**Catawba
Nuclear Station
(CNS)**

Duke Energy ERO Standardization

TSC/OSC ERO Position Comparison and Evaluation

Revision 0

Standard TSC Organization

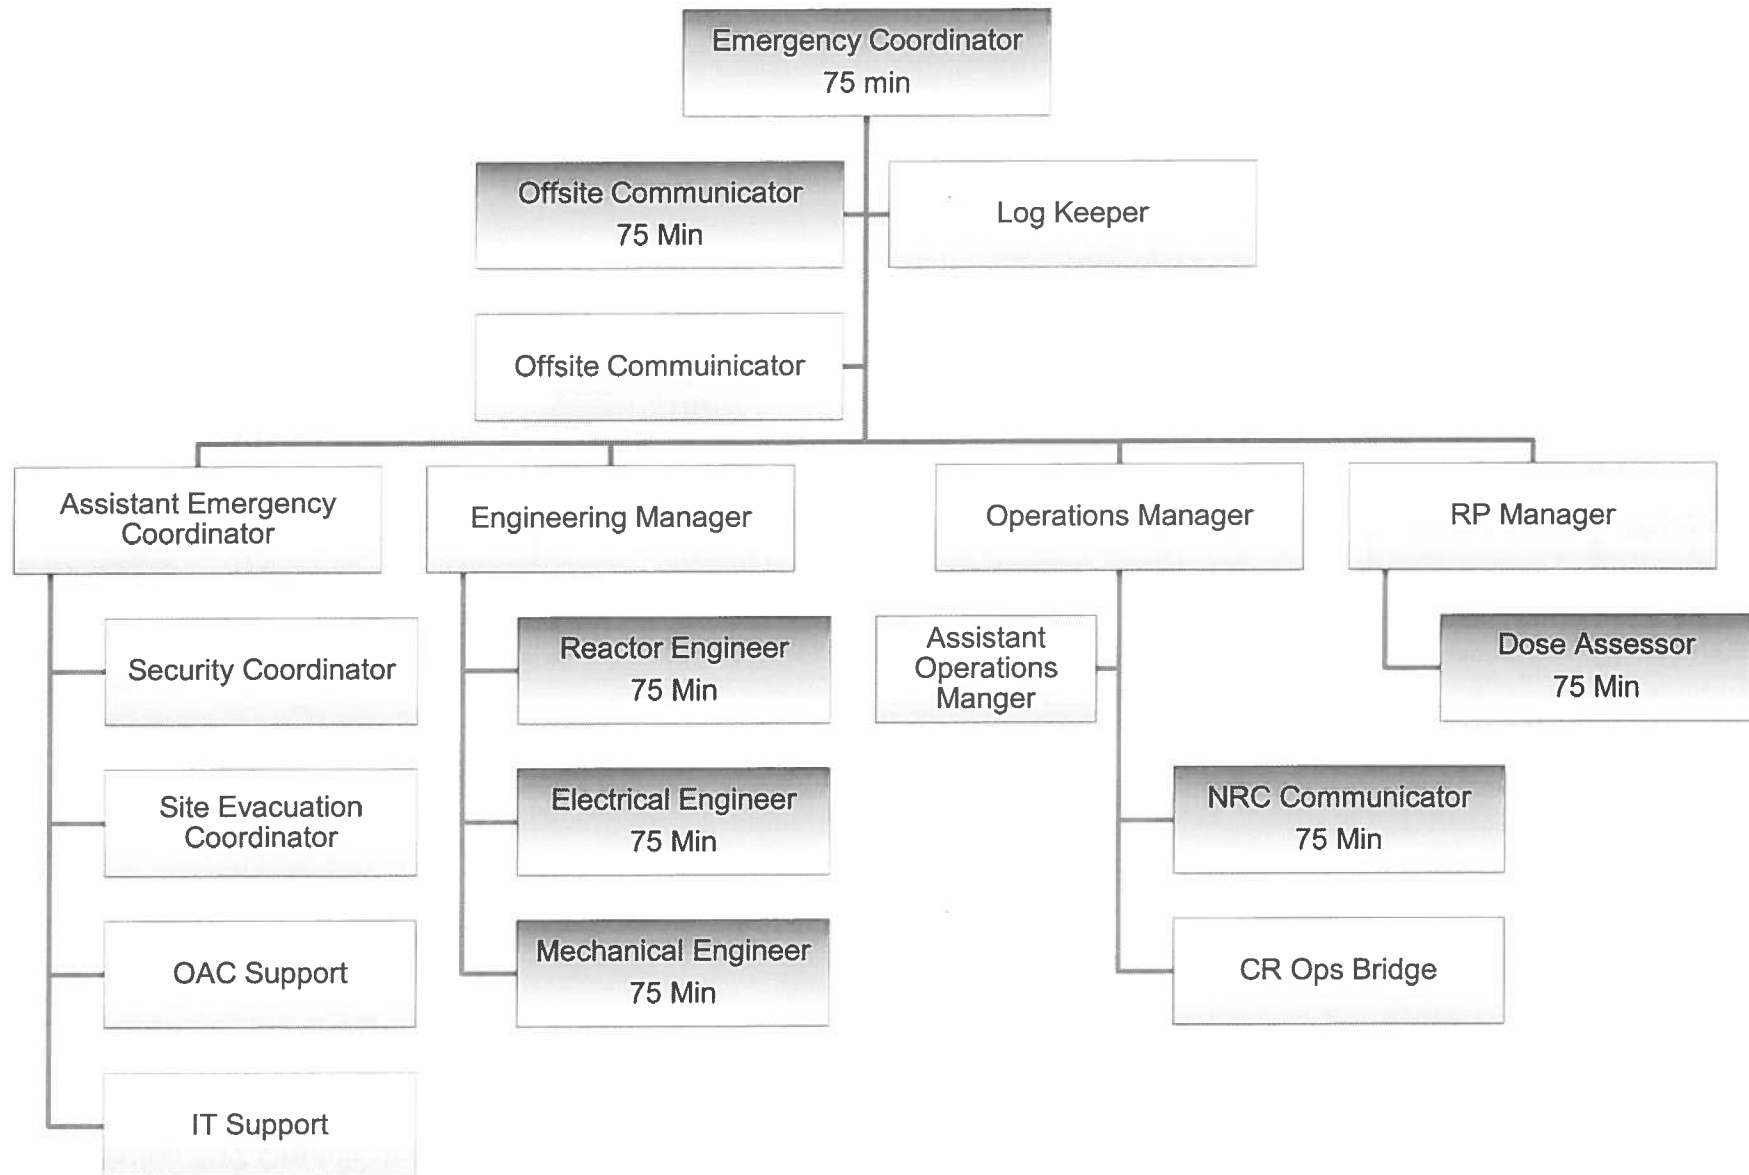
1.2.1. **TSC** – The TSC ERO staffing numbers remain at 19:

- 1) TSC IT Support was added (+1)
- 2) Electrical Engineer (moved from OSC) (+1)
- 3) Emergency Planner was removed (-1)
- 4) Assistant Operations Engineer was removed (-1)

Standard OSC Organization

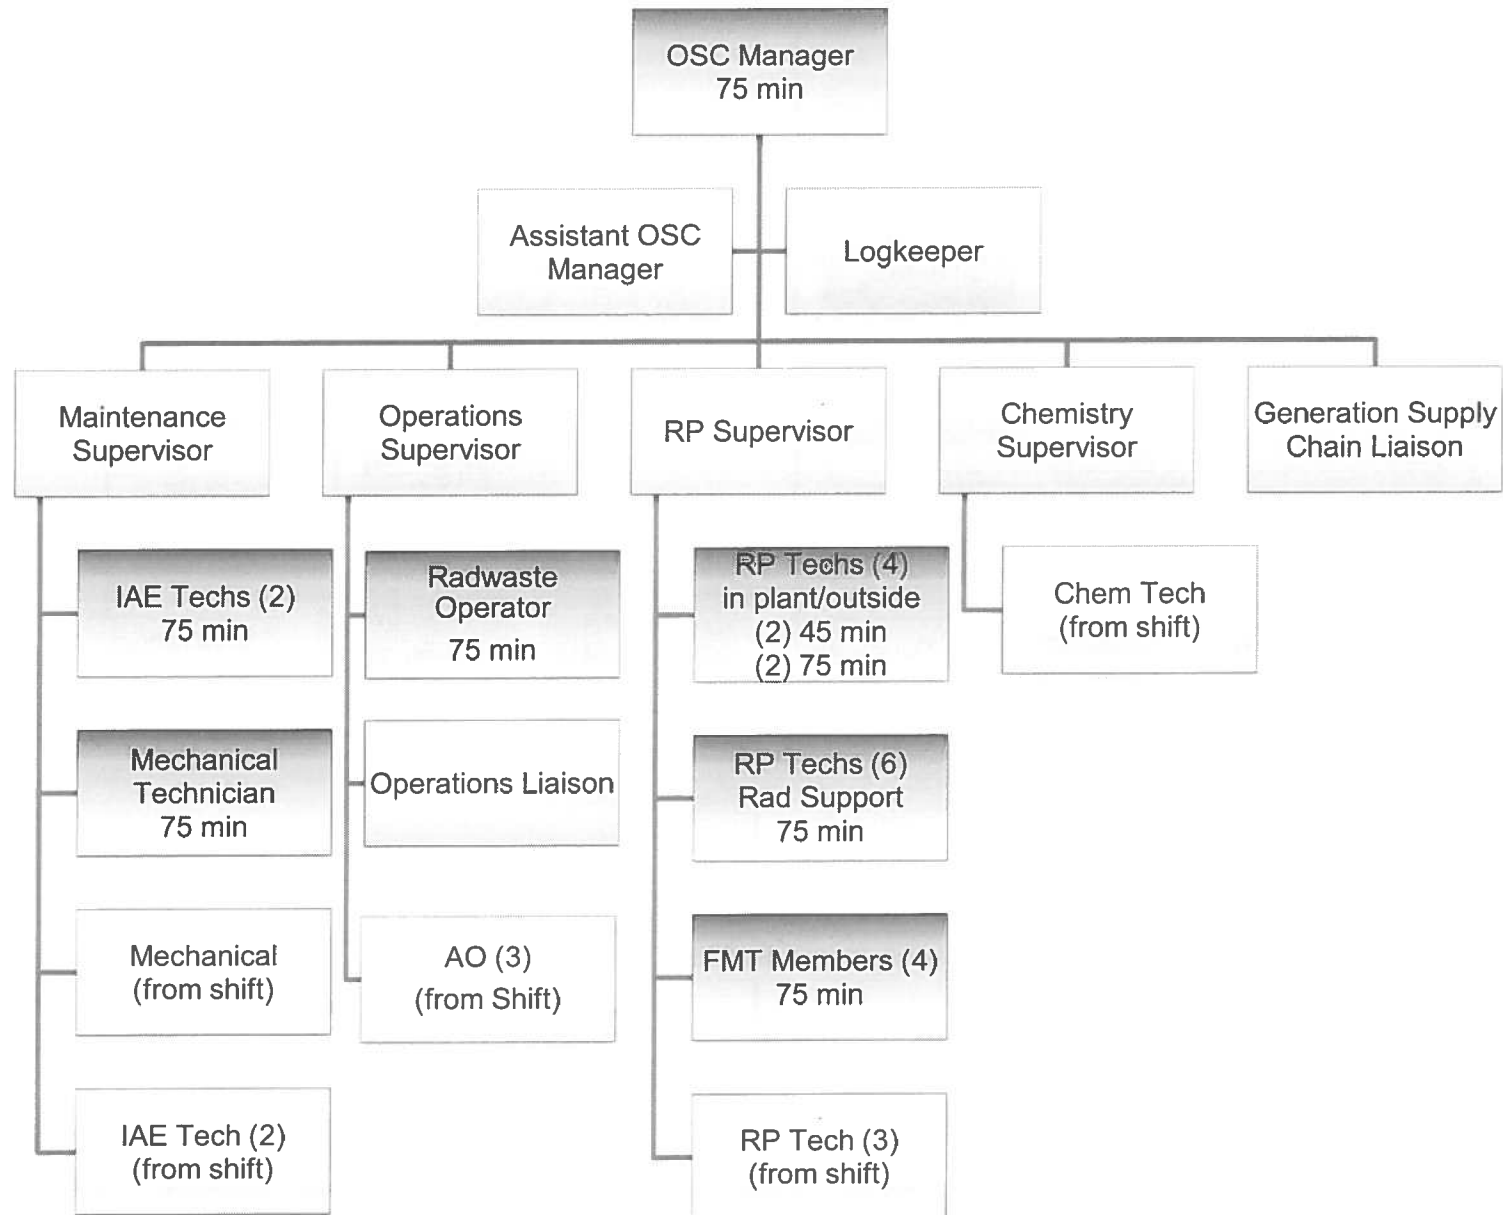
1.2.2. **OSC** – The OSC ERO staffing numbers remain at 27:

- 1) Assistant OSC Manager was added (+1)
- 2) OSC Operations Liaison was added (+1)
- 3) DRC Supervisor was removed (-1)
- 4) Equipment (Electrical) Engineer (moved to the TSC) (-1)
